STAFF REPORT
KETCHUM PLANNING AND ZONING COMMISSION
REGULAR MEETING OF AUGUST 11, 2020

PROJECT: Lofts at 660 1st Avenue Condominium Subdivision Preliminary Plat

FILE NUMBER: P20-055

Attachment B.
Preliminary Plat dated August 2020

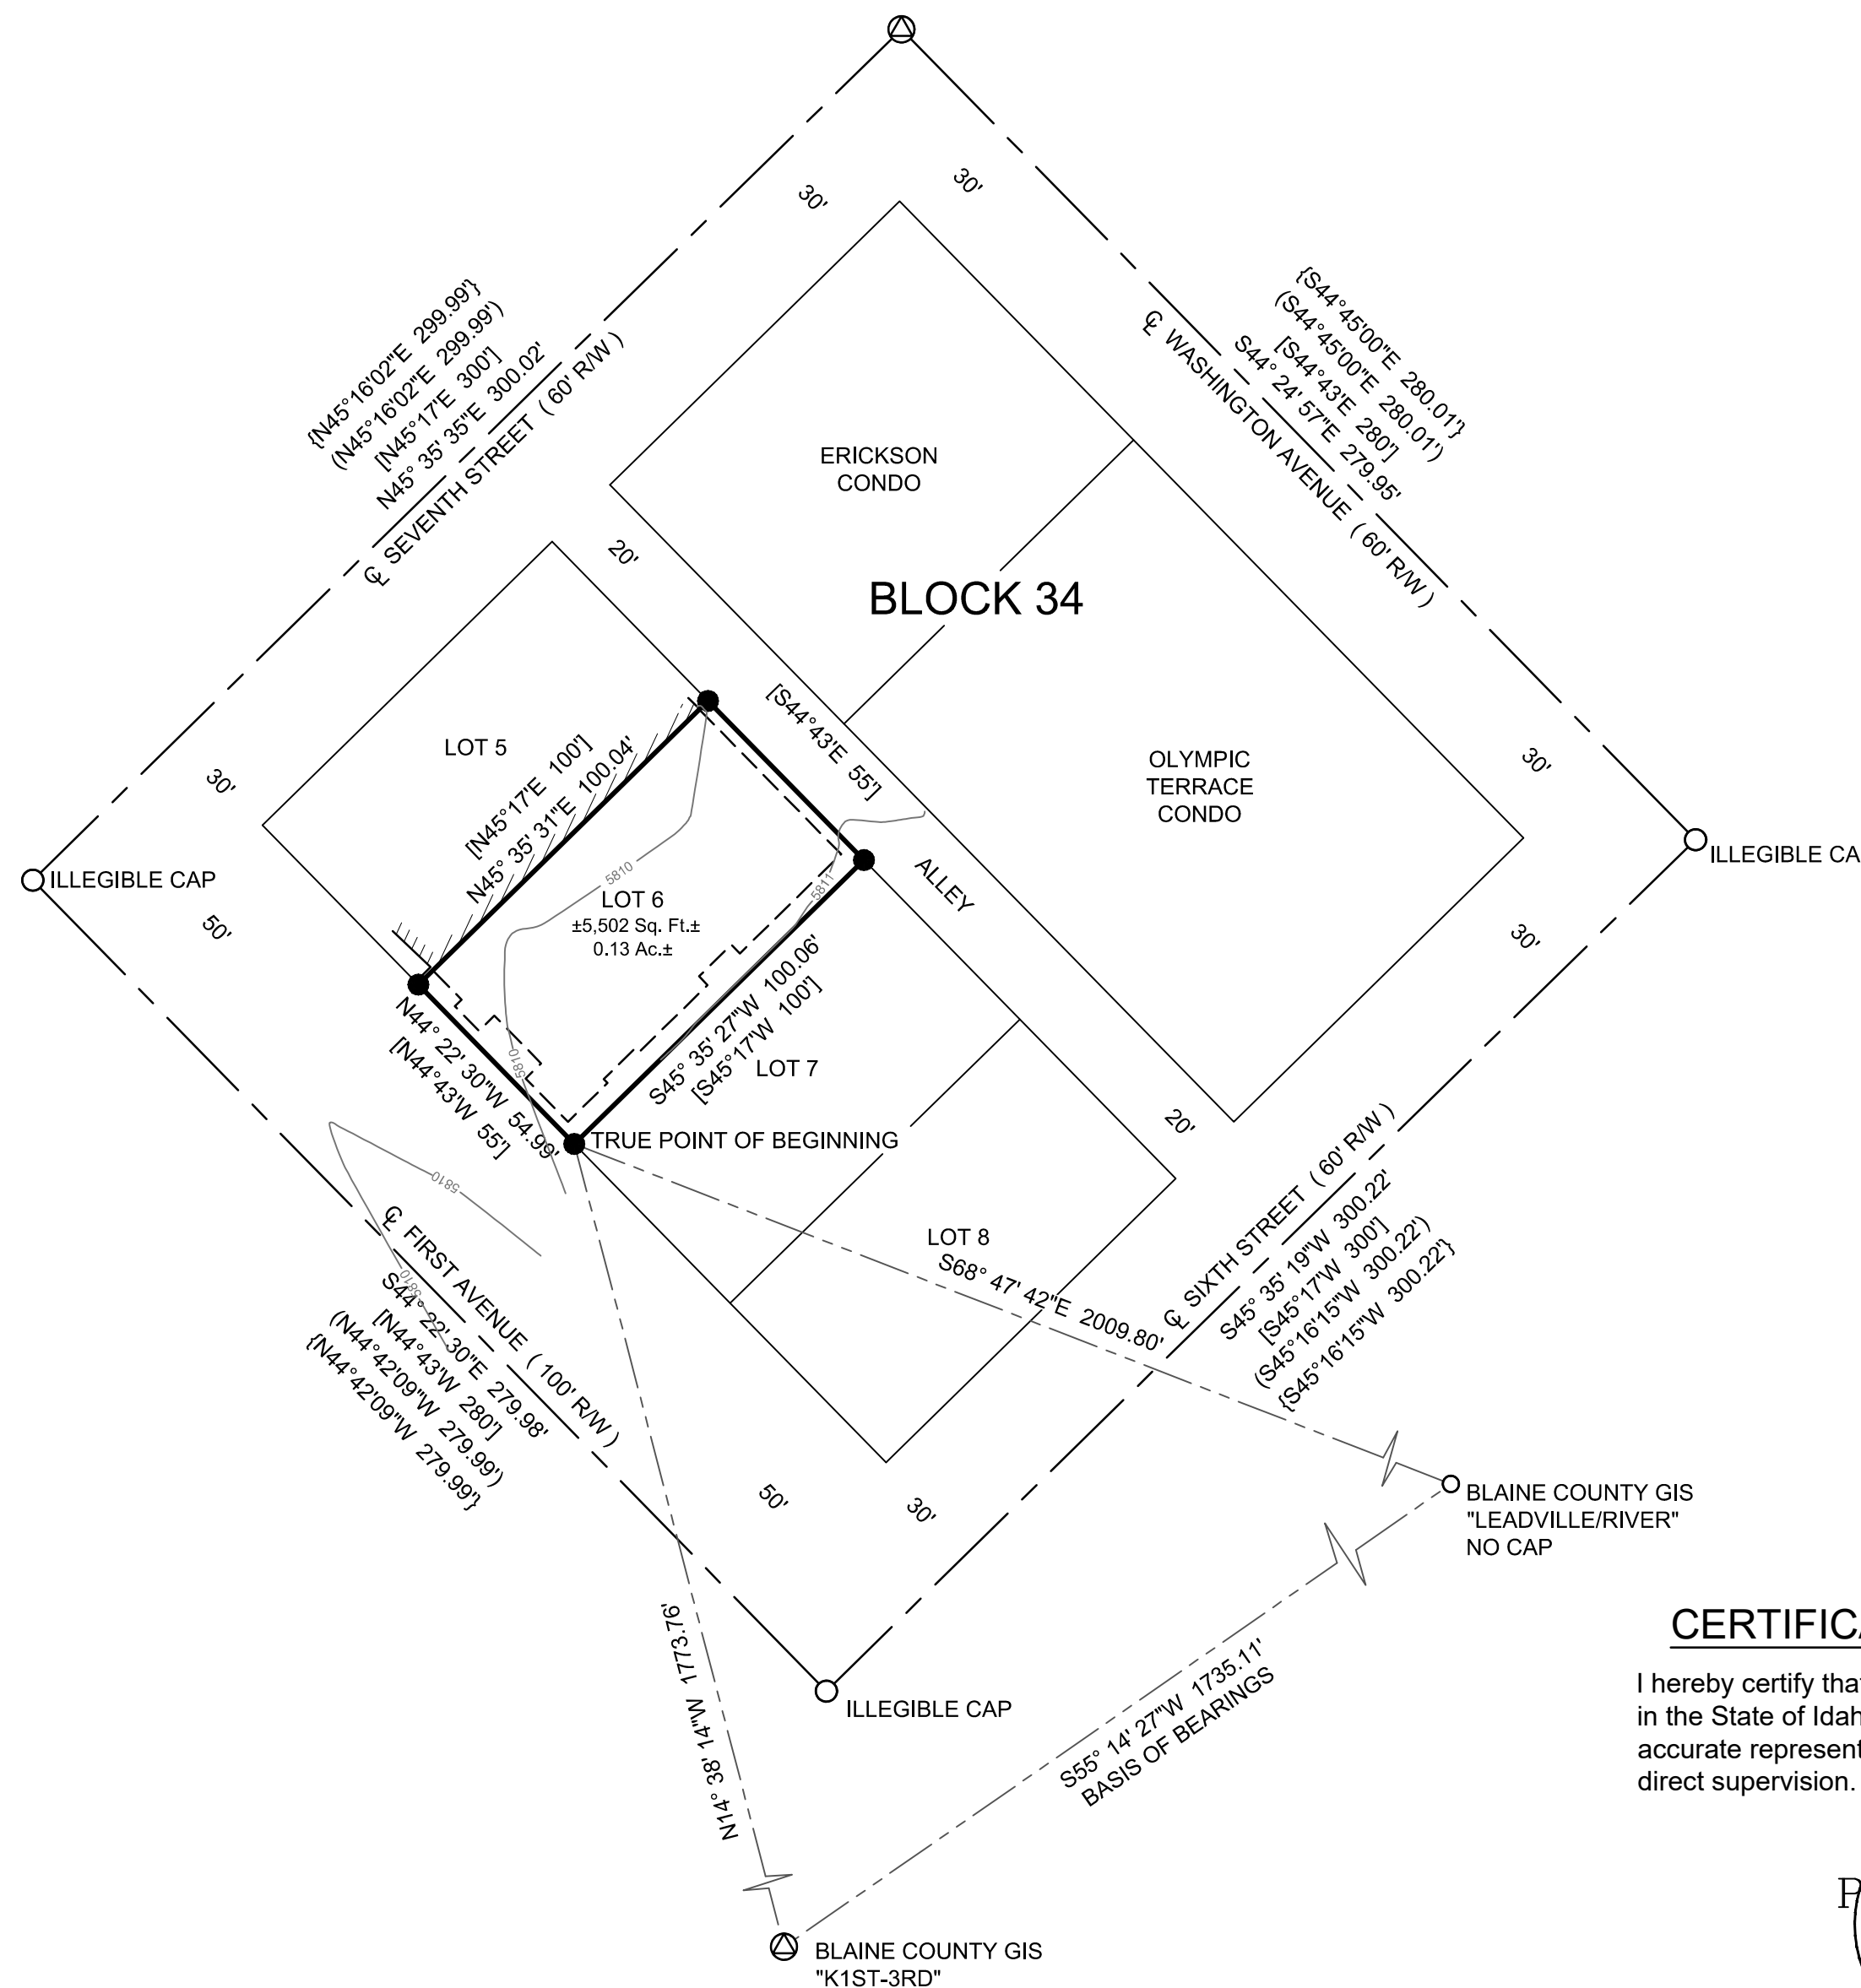
3. The recorded plat shall show a minimum of two Blaine County Survey Control Monuments with ties to the property and an inverse between the two monuments. The Survey Control Monuments shall be clearly identified on the face of the map;

N/A at this time, pertains to Final Plat.
X	<input type="checkbox"/>	<input type="checkbox"/>	16.04.070.D	D. Garage: All garages shall be designated on the preliminary and final plats and on all deeds as part of the particular condominium units. No garage may be condominiumized or sold separate from a condominium unit.
				The garages are allocated to residential units.
X	<input type="checkbox"/>	<input type="checkbox"/>	16.04.070.E	E. Storage Areas: Adequate interior storage space for personal property of the resident of each condominium unit.
				Storage units for each unit are indicated on the plat.
X	<input type="checkbox"/>	<input type="checkbox"/>	16.04.070.F	F. Maintenance Building: A maintenance building or room shall be provided of adequate size and location for the type and size of the condominium project for storage of maintenance equipment and supplies for common areas.
				A maintenance room, M, is indicated on the plat.
